The Zabudowicz Collection, 176 Prince of Wales Road, London NW5 3PT

APPLICATION FOR FULL PLANNING PERMISSION & LISTED BUILDING CONSENT

DESIGN & ACCESS STATEMENT ADDENDUM III

2 REAR GALLERY EAST WALL - Internal Elevation
121 1:50

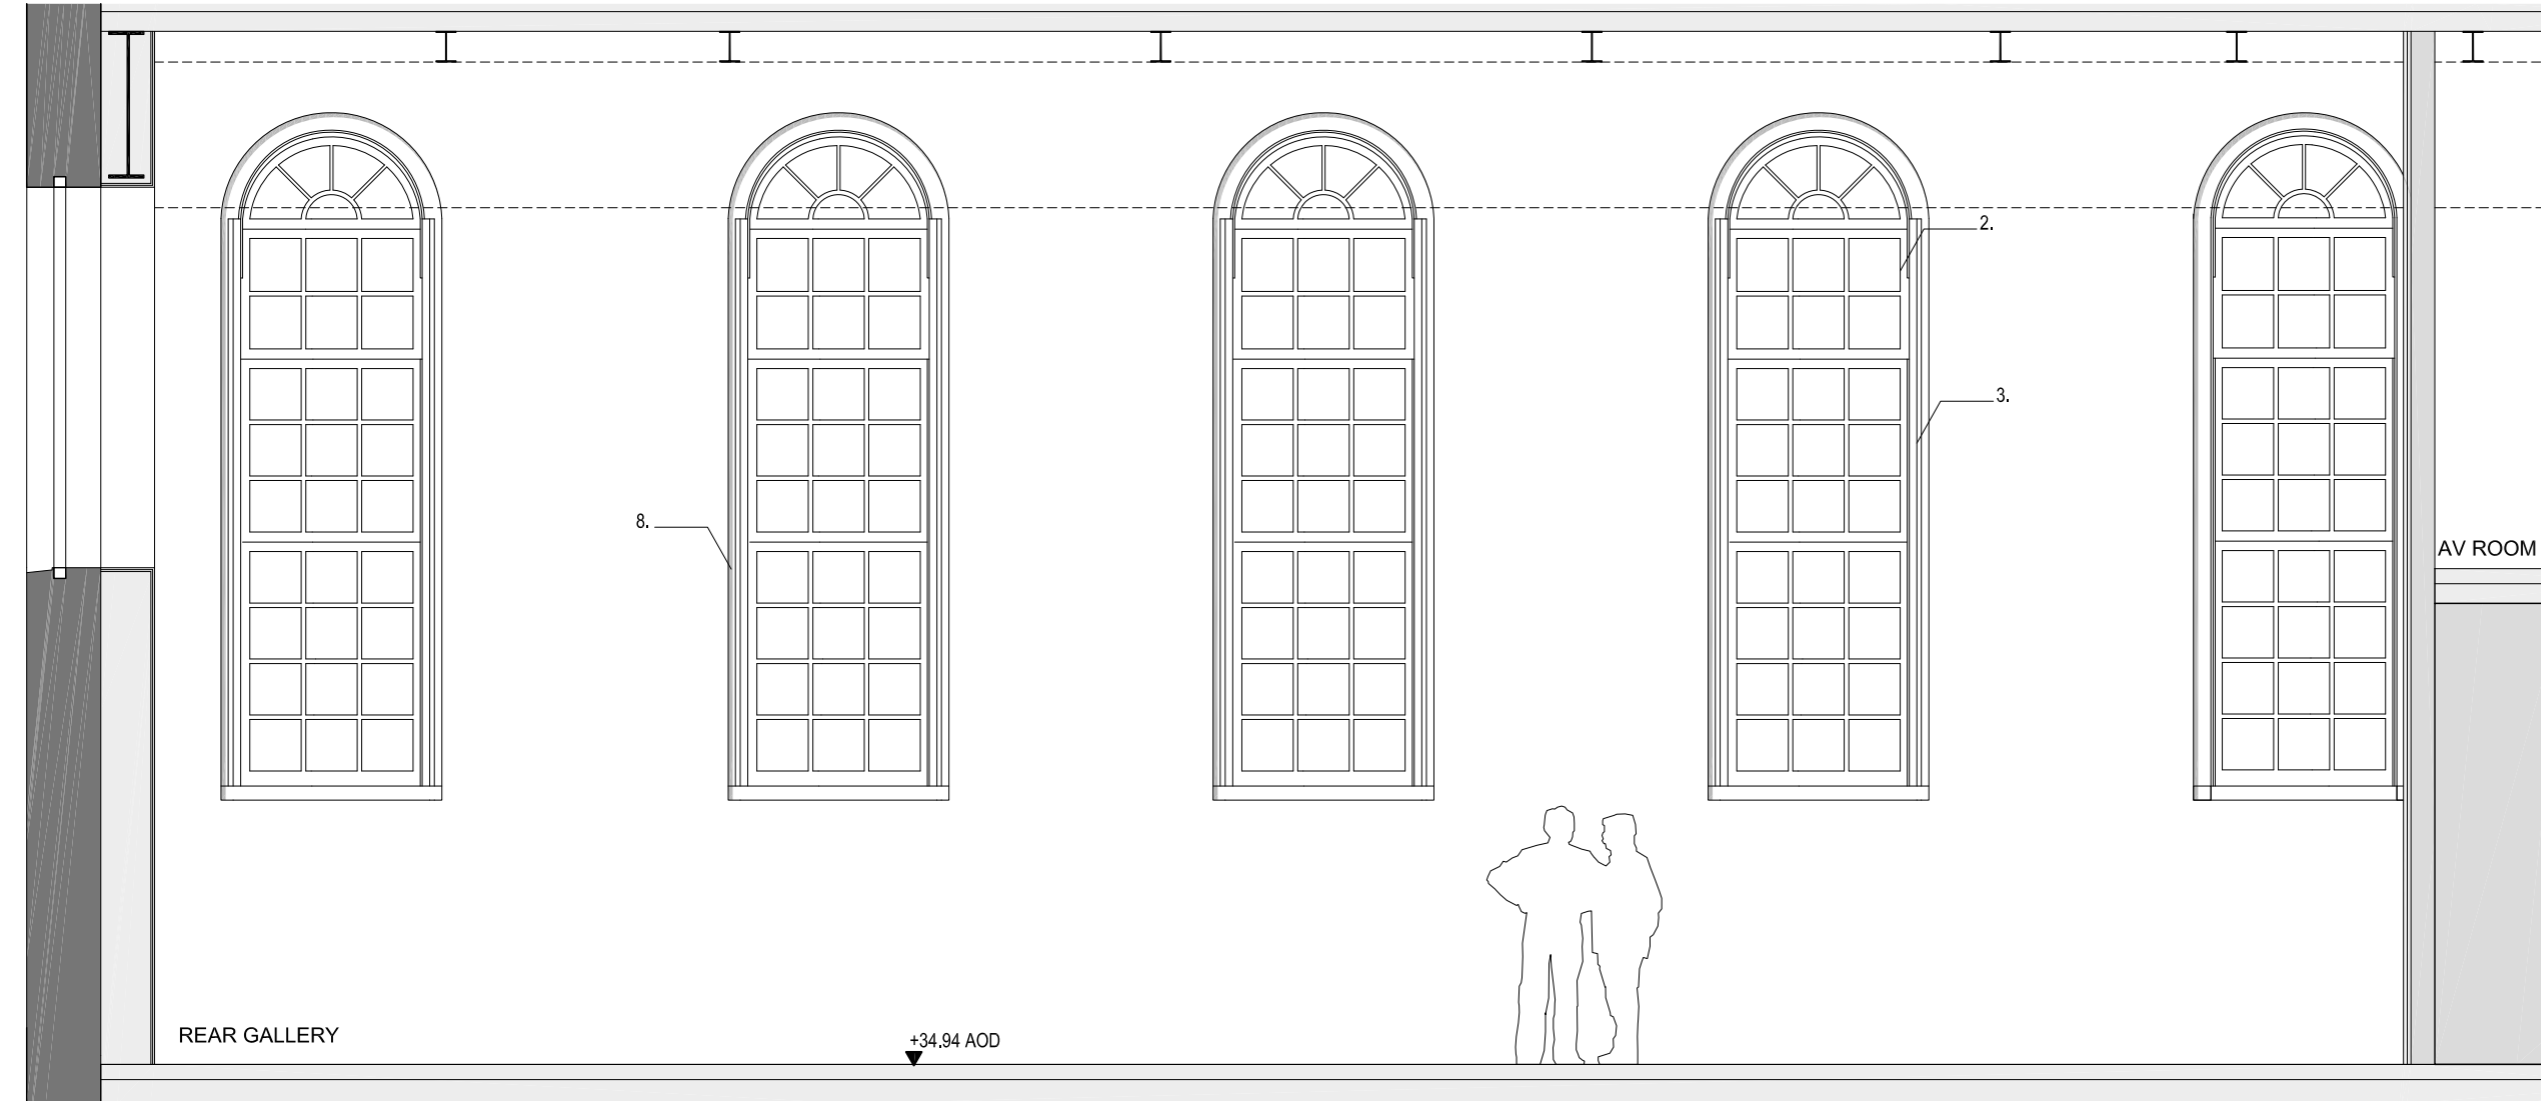
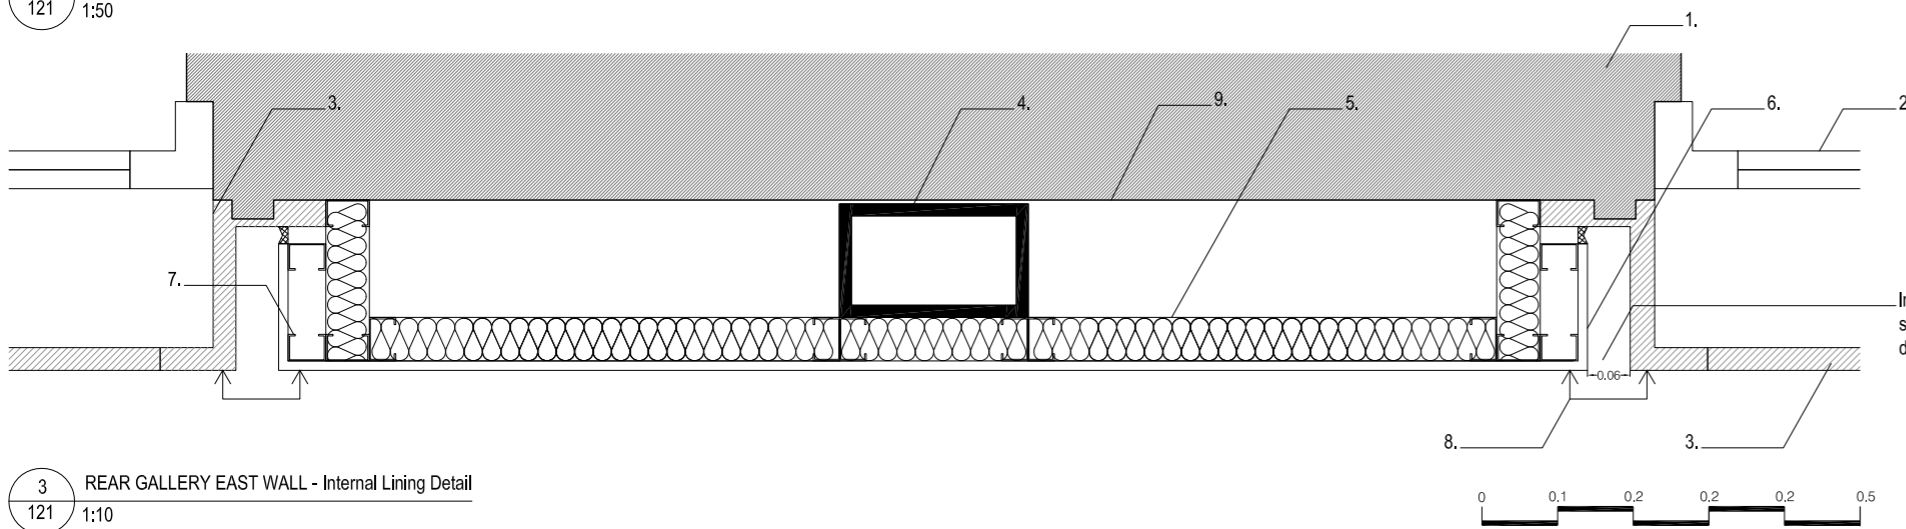
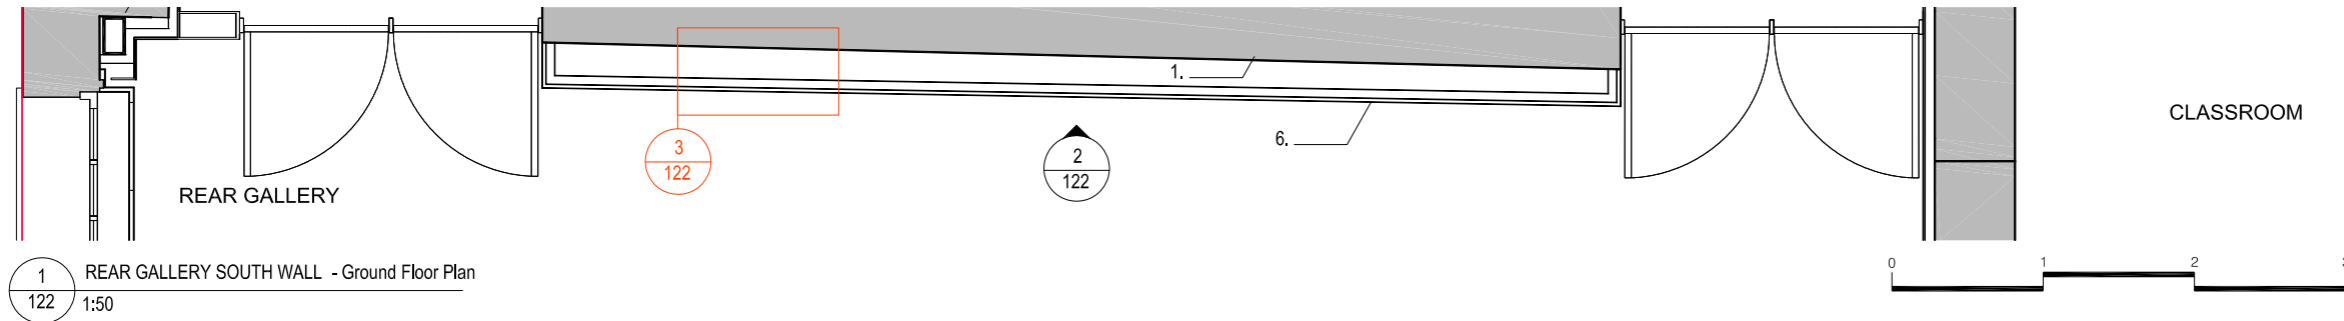
3. Detail of how the east window and shutters would sit with the new plasterboard lining flushed to the existing window box.

Existing wall is retained with windows and frames. New columns sit in front of the retained wall. The plasterboard lining sits flush with the existing protruding box of window shutters. This conceals the new column and retains the detailing of the original wall by the sheathing of the wall with the new plasterboard.

The room's existing proportions are reduced marginally, to accommodate the concealed columns.

There is a proposed 50mm shadow gap in between the plasterboard lining and window frames.

2 LIBRARY EAST WALL - Interior Elevation
125 1:50

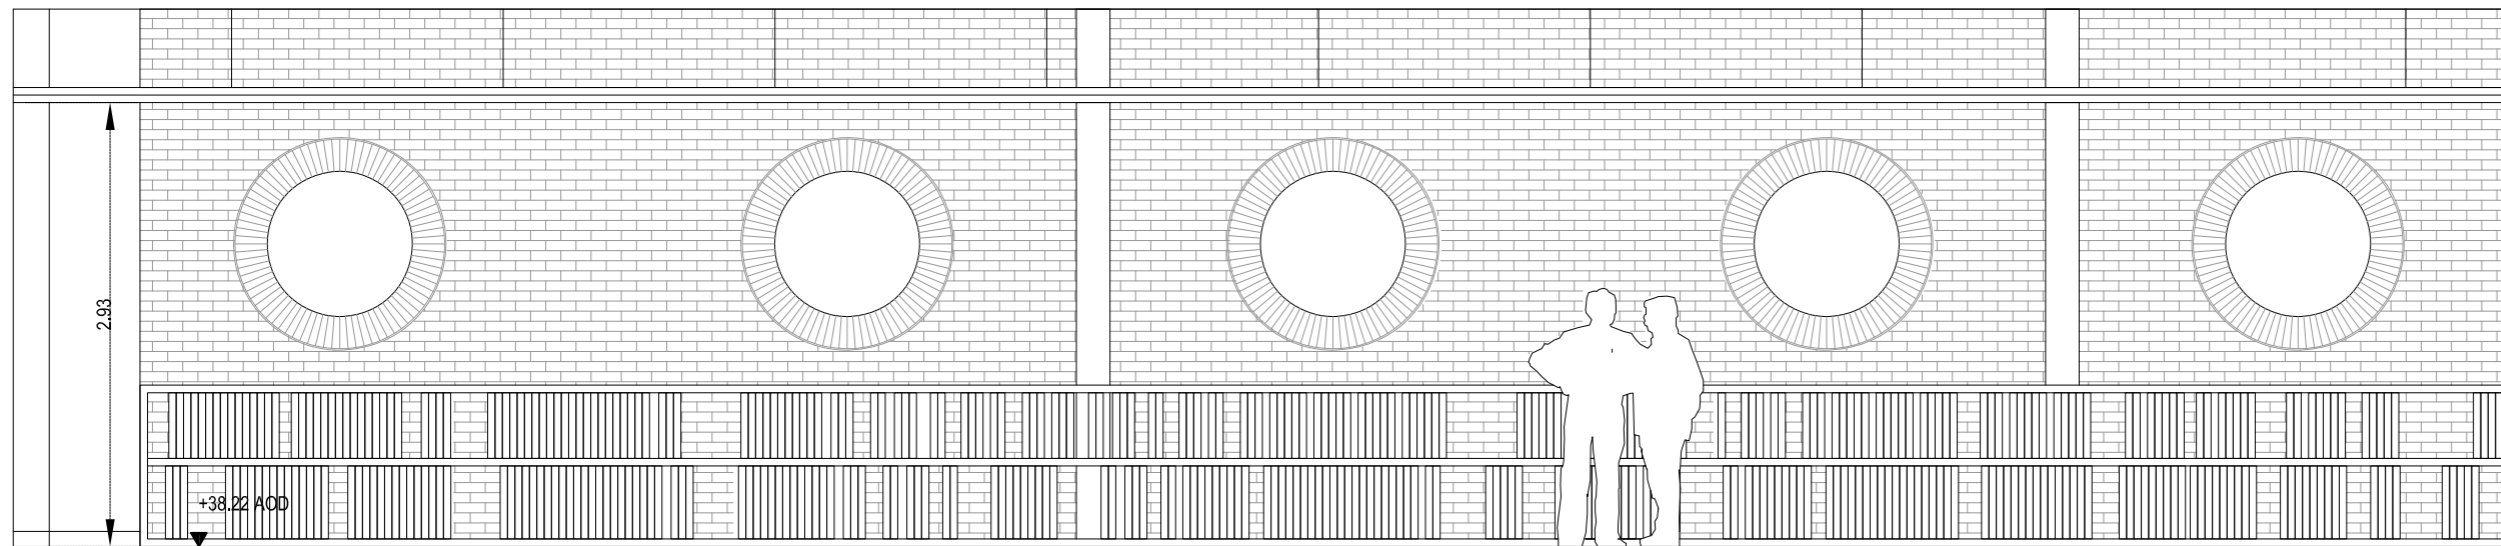
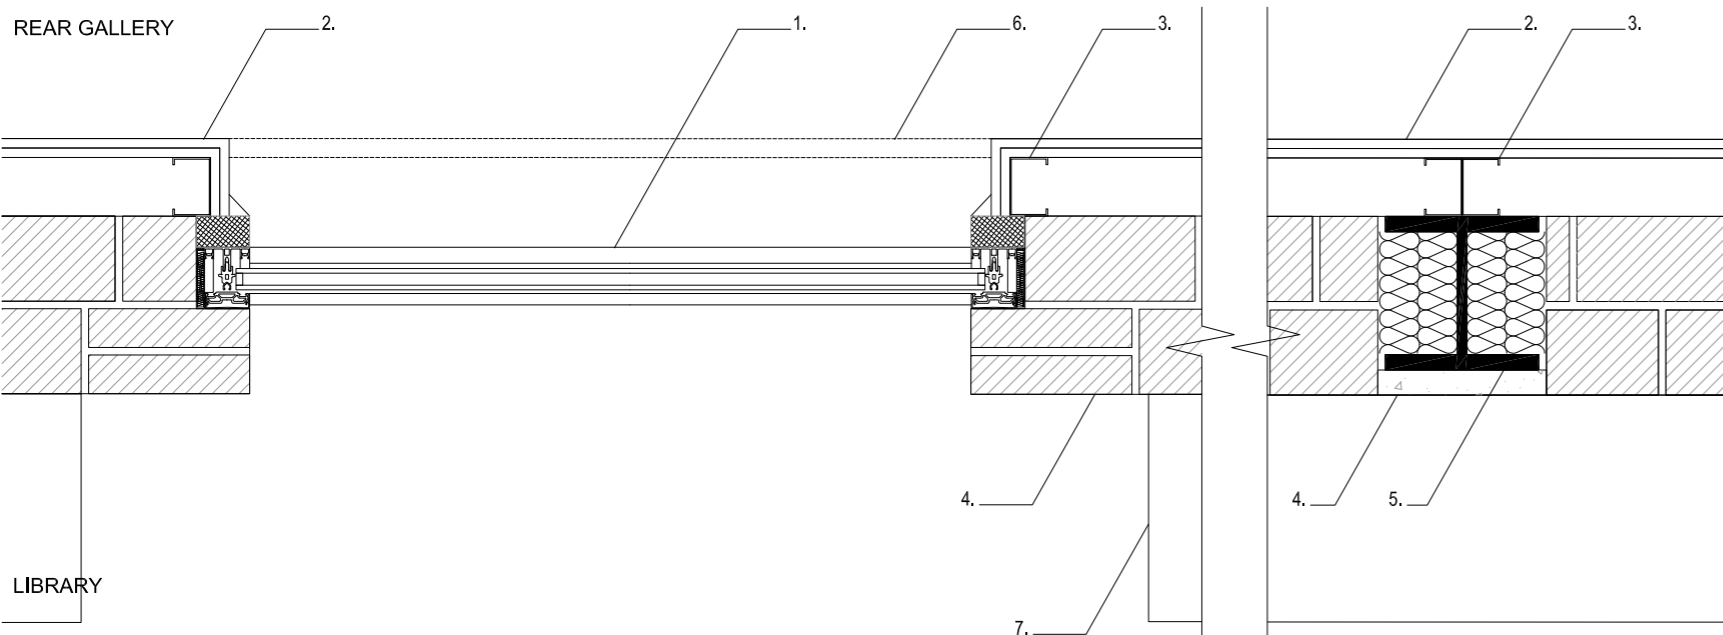
1. Inclusion of brick in the 1st floor rear gallery/library wall in keeping with the existing roundette brick wall. This is to be exposed.

2. Removal of wall separating rear gallery and corridor at ground/ first floors with an explanation of the nature of the fabric to be removed and any detailing currently in place which is covered by the plasterboard. New wall at ground floor to be built with panelling at the rear gallery matching existing. New wall at first floor to have the windows in place and detailing found currently in AV room.

The wall is rebuilt with salvaged brickwork. The windows are relocated in order to be coordinated with the location of beams and retained windows. The windows are glazed and have a recess facing the gallery allowing them to be boarded up, should the gallery require it.

The brickwork is laid in the same manner as the current wall, with the radial brick patterning. The new columns are sheathed with a cast concrete wall. The interior wall is thus exposed brick and concrete. This is the only room that shows this contrast, the traces of the extension and how it has grown from the Sunday School form.

The roundette windows, by reinstating them, further continue the project's aim of a restoration of distinct features of the former Sunday School and have them exposed in the repurposed environment.
